Mitsubishi Electric AC Servo System

No.22-13E

Change of Rotary Switch Indications on AC Servo Amplifiers for Future Compliance with ETG.5003

Figure 1. Rotary switch indication change (for MR-J5-10G-N1)

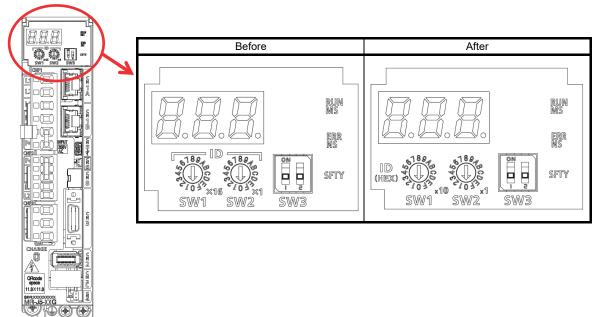
The rotary switch indication under the display cover will be changed. For MR-JET, the indication on the front cover will be changed.

- (1) MR-J5: The position of "ID" will be changed, and "(HEX)" will be added below "ID". MR-JET: "(HEX)" will be added below "ID".
- (2) The indications of "x16" and "x1" will be changed to "x10" and "x1", respectively. This change does not affect the functions and performance of the products.
